Georgia/Carolinas Prestressed Concrete
Economical Fabrication Committee

FIB STRAND TEMPLATE

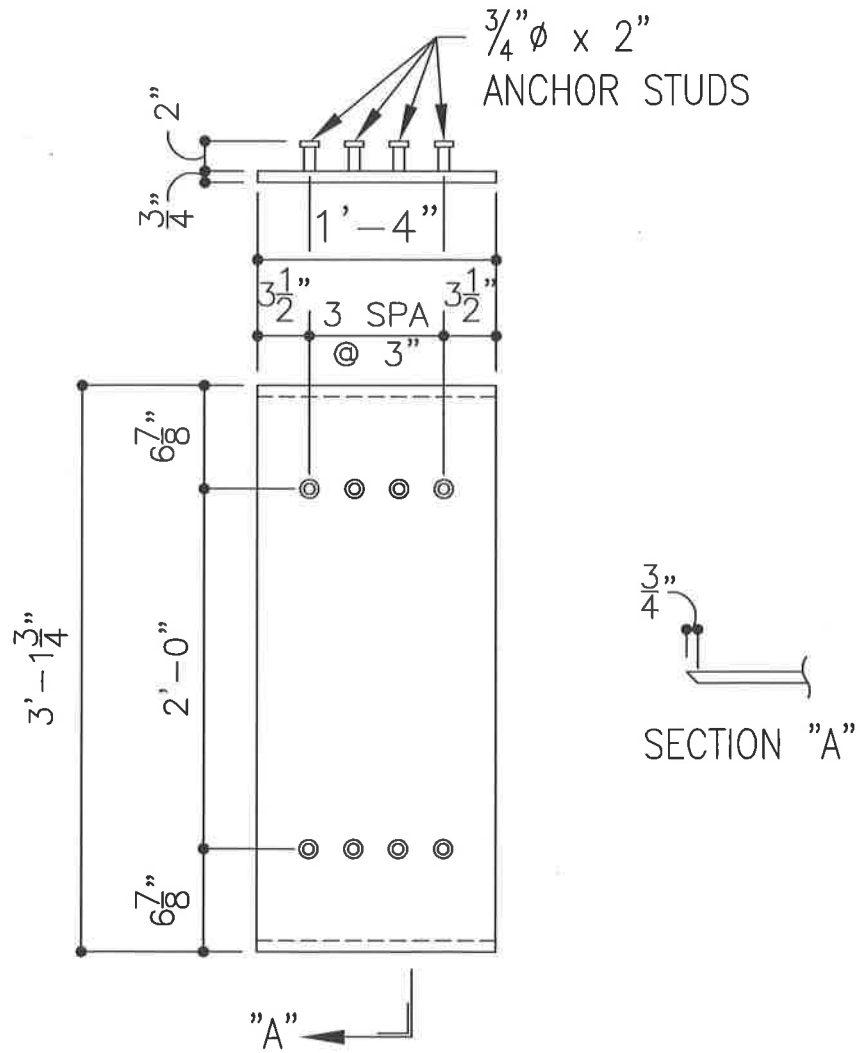
SHOULD BE 6" AS PER SDM 6.3.1.2

Should also revise SDM 6.3.1.2 which only refers to 2 top strand locations
